**Re: Hydrogeologic and Stormwater System Design Assessment
Harbor Grove Subdivision Preliminary Plat
Mukilteo, Washington
Project No. 2201001.010**

Hydrogeologic and Stormwater
System Design Assessment
Harbor Grove Subdivision
Mukilteo, Washington

Figure
1

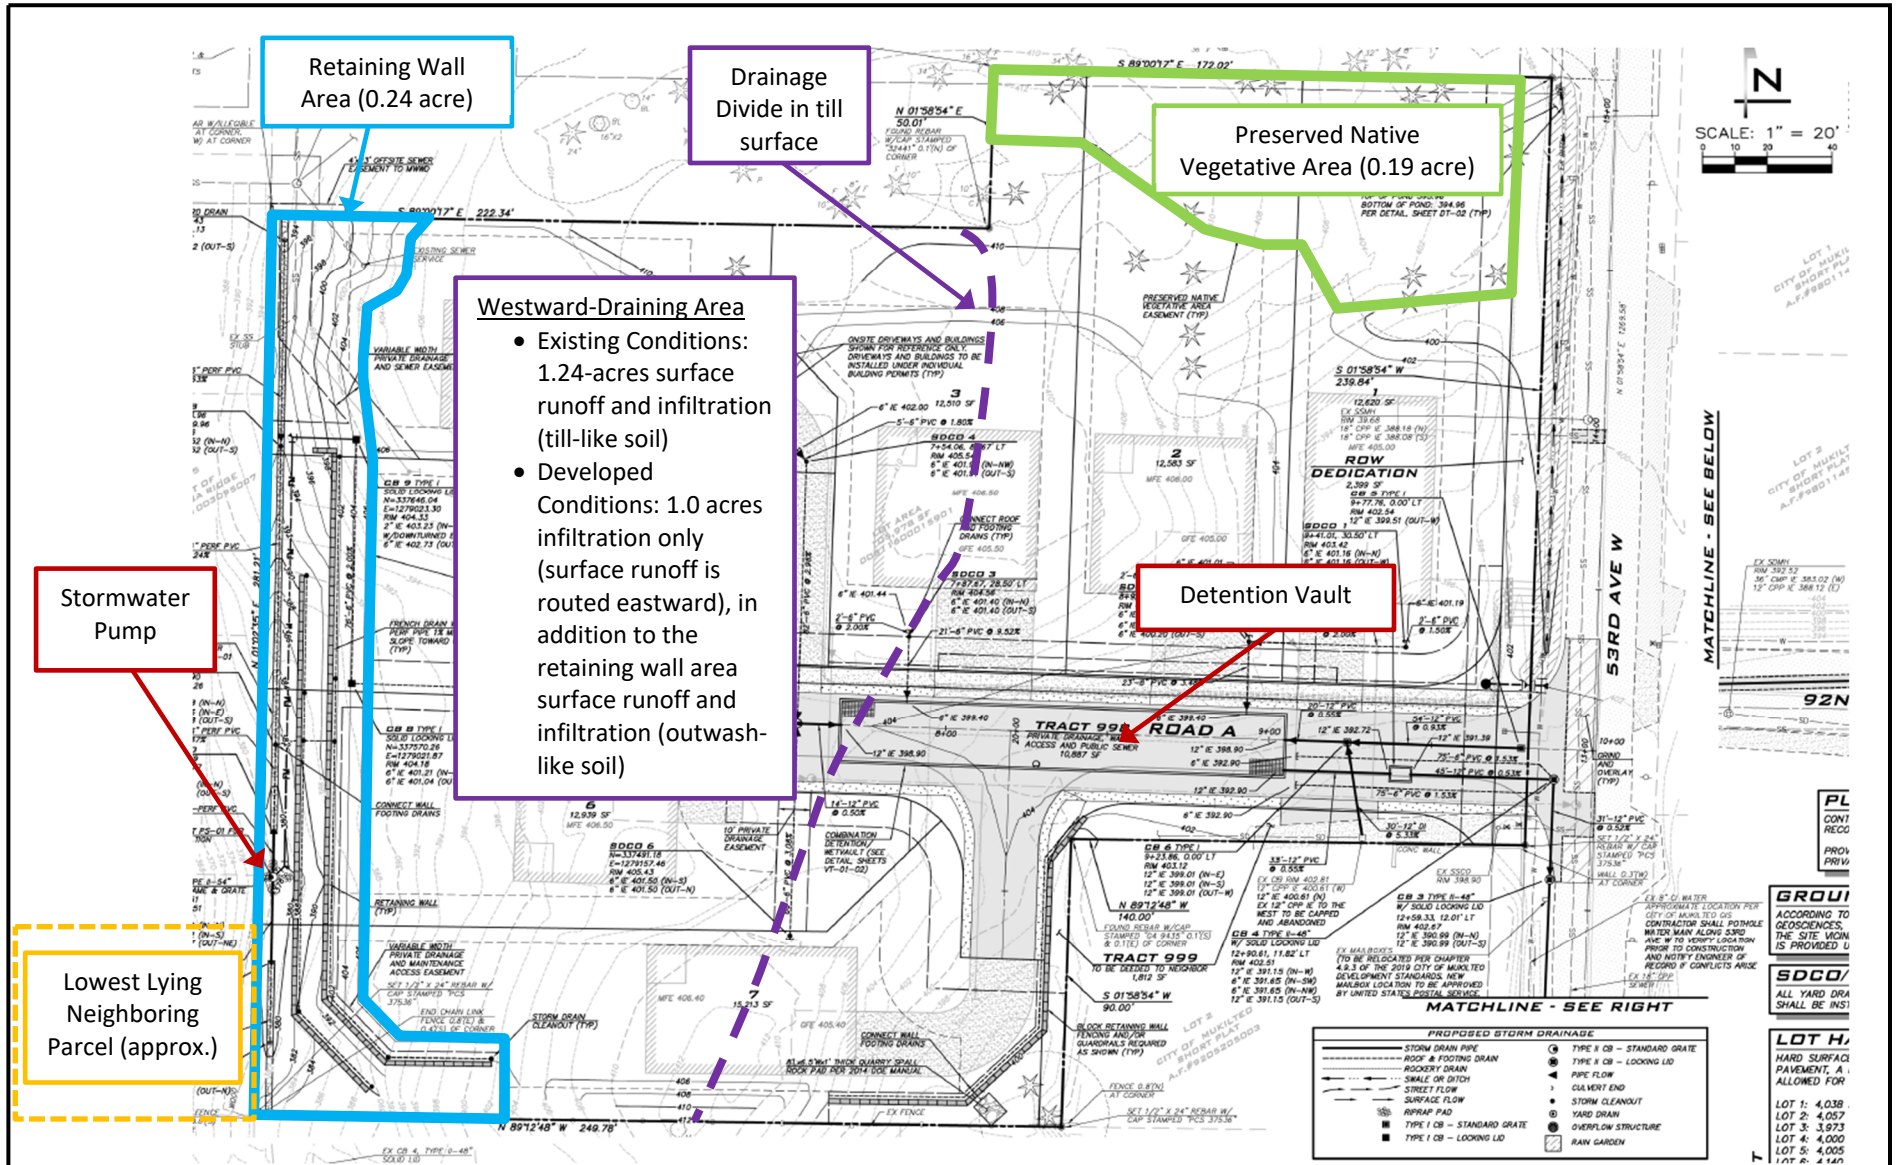
Along the same lines, the component of stormwater infiltrating to ground in the remaining 1.0-acre portion of the westward-draining area of the site under existing conditions (i.e., 1.24 acres of the Kindred existing conditions simulation minus the 0.24 acres of the Kindred simulation of proposed developed conditions of the retaining wall area; see Figure 1) would likely percolate downward from

the surface through the grading fill material, perch on top of the underlying native till, and flow west as “horizontal interflow” following the topography of the original till surface. It would then presumably be intercepted by the retaining wall drainage and pump system. In the current design, all stormwater from this 1.0-acre area is assumed to be directed to the east, a limitation that ignores infiltrated stormwater.

- Combined surface and infiltration flows from the 0.24-acre retaining wall area, assuming outwash-type (“A/B”) soils, lawn coverage, and flat slopes.
- Infiltration flows from the 1.0-acre portion of the site—where downward percolating stormwater would likely perch on top of the underlying native till, flow west following the topography of the underlying till, and be intercepted by the retaining wall area drainage and pump system—assuming outwash-type (“A/B”) soils, land coverage in accordance with proposed site conditions within this area, and flat slopes.
- Incorporate an emergency backup drainage and conveyance system to bypass the designed pump system and convey drainage past, and to reduce the risk of impacts to, the low-lying neighboring parcel(s) immediately west of the site, in the event of prolonged power failure or other pump system malfunction.
